Aeronautical Charting Forum 15-02 Reston, VA

AERONAUTICAL CHARTING FORUM (ACF)
MEETING 15-02 October 27, 2015
HOST: United States Geological Survey (USGS)
12201 Sunrise Valley Drive
RESTON, VA 20192

INSTRUMENT PROCEDURES GROUP (IPG) AGENDA

Figure 2a – MOONY3 SID SJC – Current:

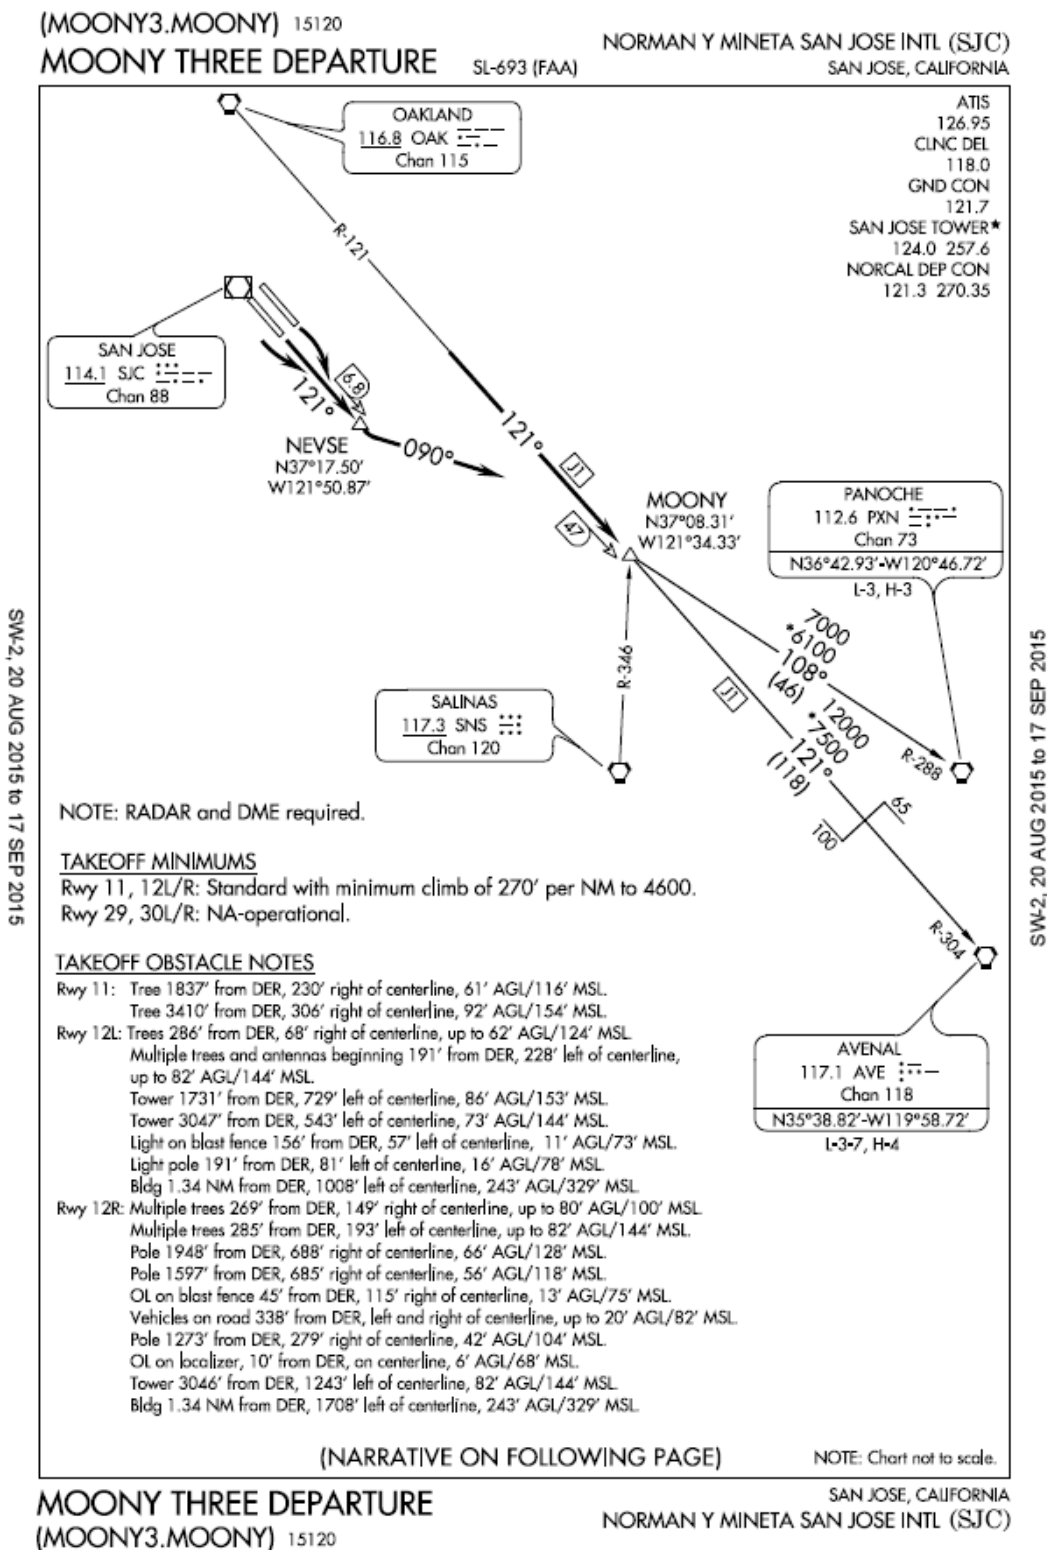
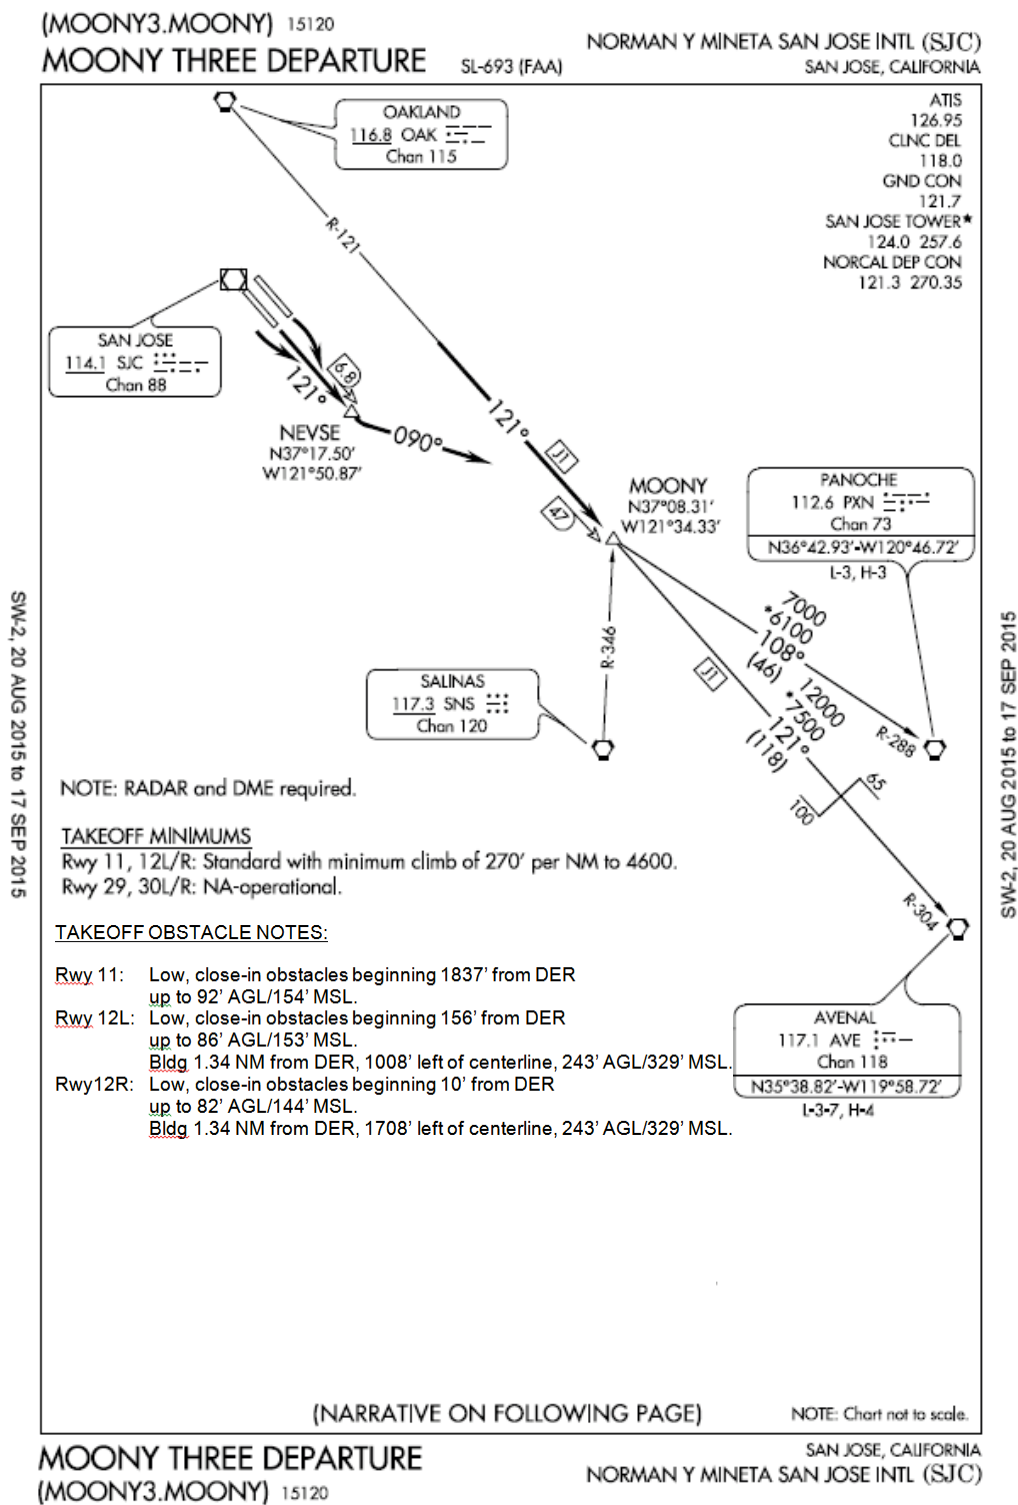
NBAA, with the support of other Industry partners, recommends that Order 8260.46 be amended to remove the requirement to publish the location of each individual or group of low, close in obstacles on SIDs and ODPs. In place of this requirement, we recommend that the “Takeoff Obstacle Notes” sections for the applicable 8260 Forms be changed to publish when low, close-in obstacles that are identified for a departure runway, document the existence of these obstacles along with the height of highest of these obstacles and the distance of the closest obstacle from the DER, as shown below:

Figure 1 depicts the current ODP entry for St. Cloud MN (STC) and the proposed change to the depiction of low, close-in obstacles. Figures 2a and 2b depict the current MOONY3 SID at San Jose, CA (SJC) and this chart with the proposed change.

In addition to reducing the complexity of the obstacle notes, attention is drawn to the obstacle(s) that must be visually avoided when using the higher than standard takeoff minimums in lieu of a higher than standard climb gradient (obstacle highlighted in red on the STC example – for reference in this document only - we are not suggesting red be used for publication). The revised note regarding low, close-in obstacles still furnishes the pilot with sufficient information for planning purposes to aid the pilot in vertically avoiding these obstacles.

Figure 2b – MOONY3 SID SJC – Incorporating Proposed Change:

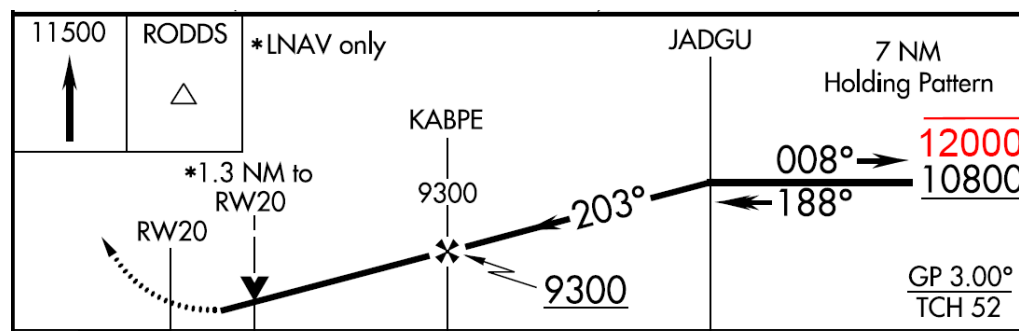
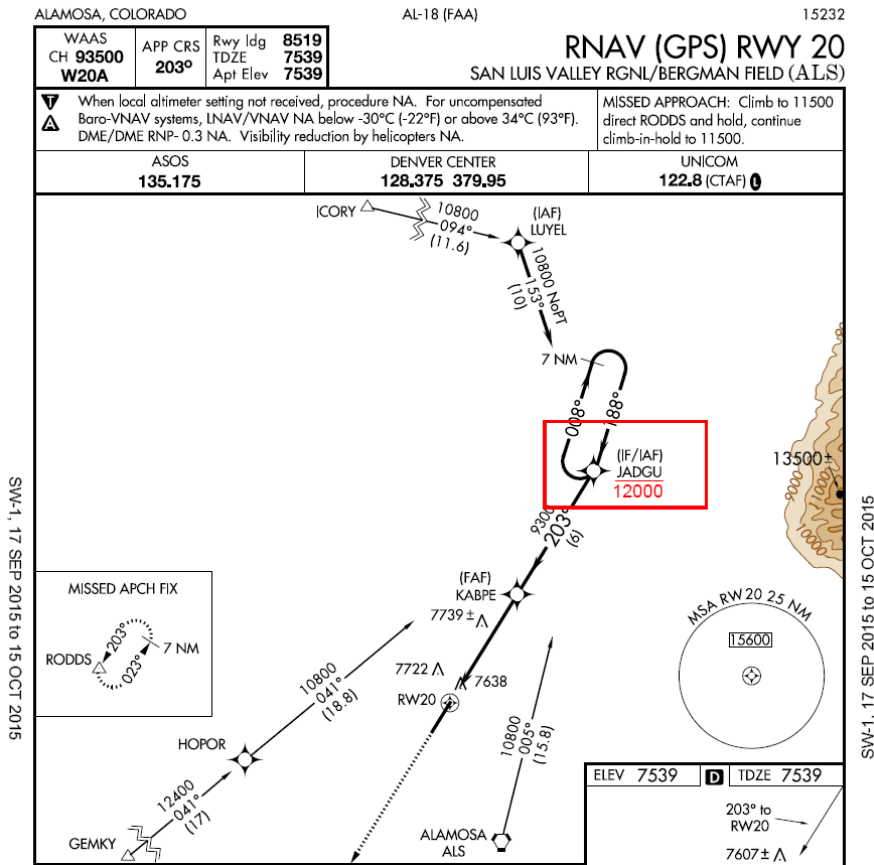
NBAA proposes that the same charting requirement applicable to a procedure turn when the 10,000' and below template is used, which is to chart a maximum "at or below" altitude at the IAF, be applied to a HILPT when a maximum holding altitude is specified on the 8260-2 Form. If this maximum holding altitude is specified for ATC-purposes, then this maximum altitude need not be published on the procedure chart.

Using the Alamosa RNAV (GPS) Rwy 20 approach example, JADGU would have an "at or below" 12,000' MSL altitude limit depicted in the profile view, as shown below:

Alternatively, a window, "at or below" and "at or above" altitude can be charted in the profile view. We invite the assistance of the ACF to determine the preferred method:

Figure 1

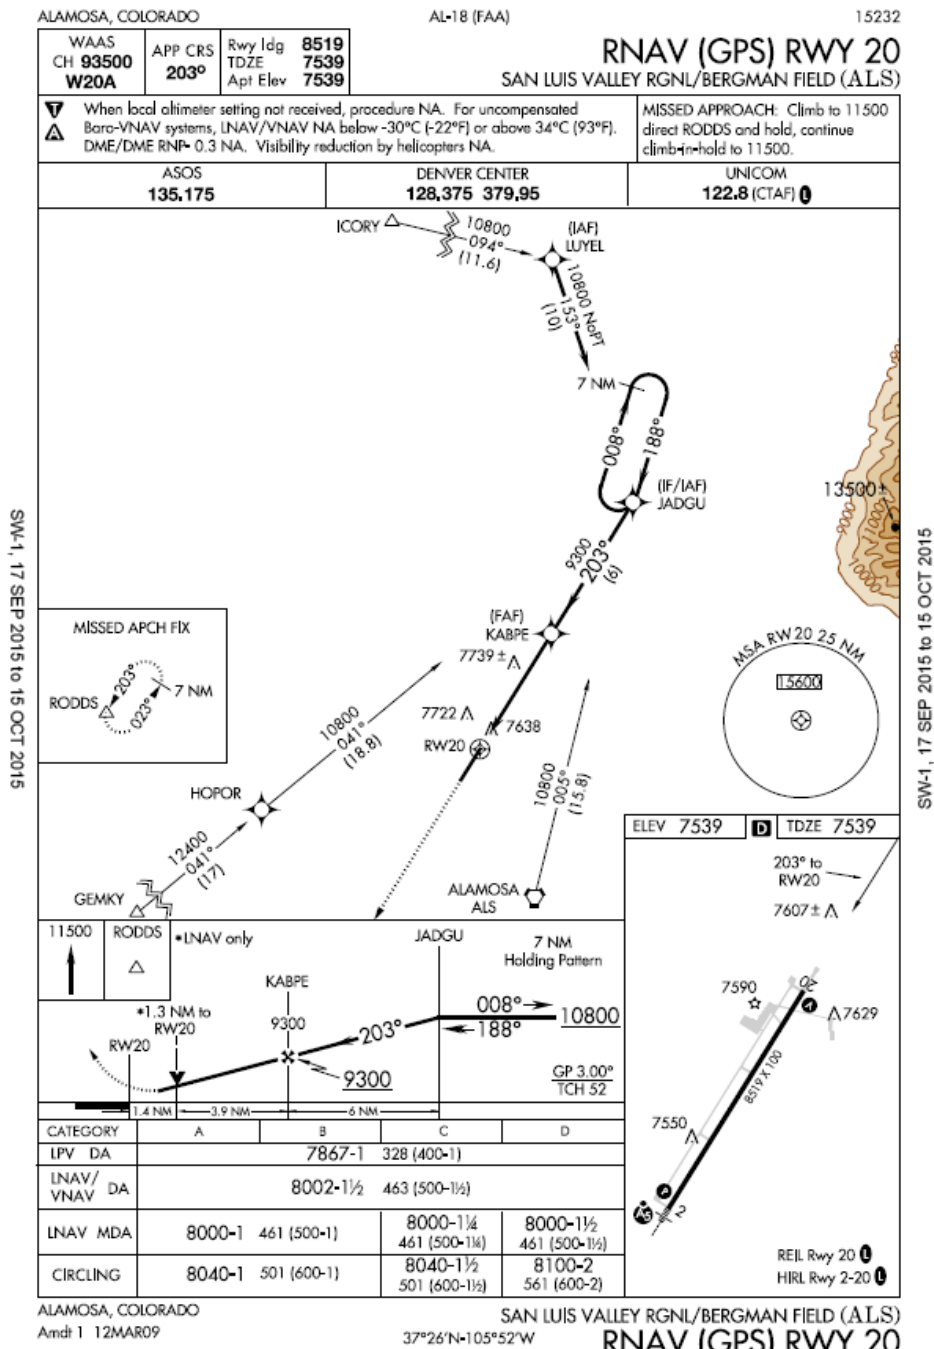
Figure 1 shows the RNAV (GPS) Rwy 20 approach at Alamosa, CO (KALS). The HILPT altitude is 10,800' MSL. Figure 2 shows the FAA 8260-2 Form for JADGU. The maximum holding altitude shown at JADGU is 12,000' MSL. Figure 2 depicts the protected airspace for the HILPT at JADGU based on the P10 pattern. Use of this pattern is required to allow the HILPT protected airspace to remain clear of the terrain to the east of Alamosa. A larger holding pattern would permit holding above 12,000' MSL. However, because of the terrain to the east, the use of a larger holding pattern template is not possible at this location.

Figure 4

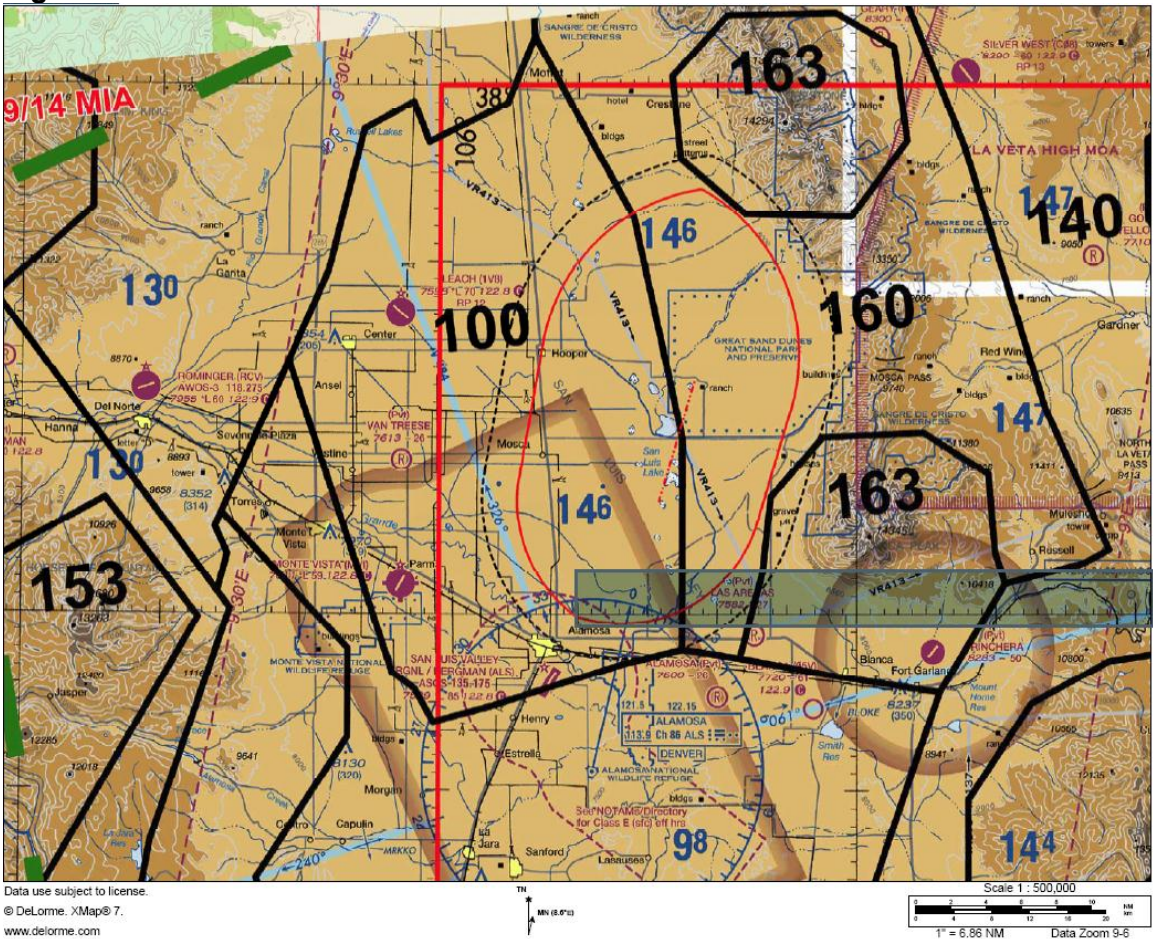
Figure 4 shows an overlay of the MIA altitudes in the vicinity of ALS. At most airports, ATC can bring the aircraft to the HILPT at or above the MVA or MIA and below any maximum holding altitude published on the 8260-2 Form. However, at Alamosa the MIAs east of the holding pattern protected airspace are at or above 16000' until just prior to JADGU. It is nearly impossible for ATC to clear an aircraft direct-to JADGU from the east at the 16000' MIA, and then descend the aircraft to cross JADGU at or below 12,000' as required by the holding pattern's maximum altitude prior to clearing it for the approach. This would require a descent of 4000 feet in little over 2 miles.
